Re: Response to Information Request  
Development Application for a Development Permit for Reconfiguring a Lot (2 into 3 lots) located at 9 & 11 Oberon Street, Morningside also described as Lots 201 & 202 on RP94762  
Council Ref: A007047753

I refer to Council's Information Request dated 14 July 2026 in relation to the abovementioned application and herein provide a "full" response to all matters raised.

**Figure 1: Confirmation of On-Street Parking Availability and all existing Street Trees**

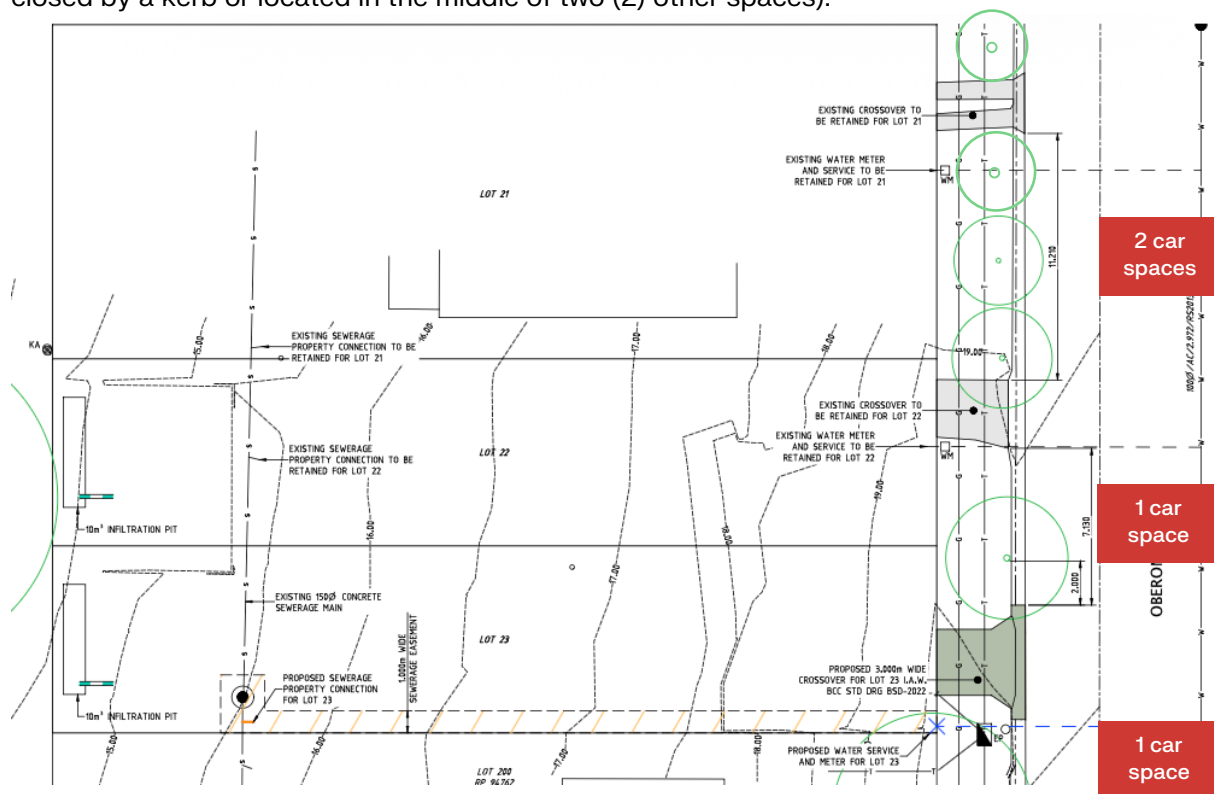
*The frontages for proposed Lots 22 and 23 are less than 10m. In order to demonstrate compliance with PO27/AO27.4 of the Subdivision code, a shared access should be provided centrally along the proposed common property boundary of Lots 22 and 23.*

*To facilitate the outcome, the street tree fronting Lots 22 and 23 will need to be removed. The street tree has been programmed for removal by Public Space Operations Arboriculture Delivery as it meets the removal and replacement criteria due to its poor condition.*

*a) Submit an amended plan of subdivision and concept services sketch which identifies the required combined driveway crossover for Lots 22 and 23. The crossover is to be centred on the shared boundary between the two proposed new lots.*

The proposal is considered to wholly comply with AO27.4 of the *Subdivision code* and, for the reasons outlined below, a shared access crossover centred on the common boundary of proposed Lots 22 and 23 is not considered to represent the best planning outcome for the site.

As demonstrated in **Figure 1**, the proposed design facilitates the provision of four (4) on-street car parks between 9 Oberon Street's existing crossover and 15 Oberon Street's existing crossover, in addition to retaining the five (5) existing street trees along the frontage. This is achieved as follows:

- 2 on-street car parking spaces of 5.4m (totalling 10.8m) within the 11.2m available between 9 Oberon Street's and Lot 22's existing crossovers;
- 1 on-street car parking space of 5.4m within the 7.13m available between Lot 22's existing crossover and Lot 23's 3.0m wide proposed crossover; and

- 1 on-street car parking space of 5.4m within the 5.6m available between Lot 23's 3.0m wide proposed crossover and 15 Oberon Street's existing crossover.

The on-street car parking lengths accord with Figure L in the *Transport, access, parking and servicing planning scheme policy*, given that each space is at the open end of the row (i.e. not closed by a kerb or located in the middle of two (2) other spaces).

Furthermore, if a shared 6.0m wide Type A crossover centrally located over the common boundary of proposed Lots 22 and 23 were required, the available on-street parking would reduce as follows:

- 14.21m between 9 Oberon Street's existing crossover and Lot 22's proposed crossover; and
- 9.0m between Lot 23's proposed crossover and 15 Oberon Street's existing crossover.

This arrangement would yield only three (3) on-street car parking spaces, being one (1) fewer than the proposed design, and would require the removal of an existing street tree, resulting in a poorer planning outcome against AO27.4 of the *Subdivision code*. The proposed design, by contrast, achieves full compliance with AO27.4 while retaining all existing street trees and is therefore considered to represent the superior outcome. For these reasons, no changes to the original access arrangements are proposed.
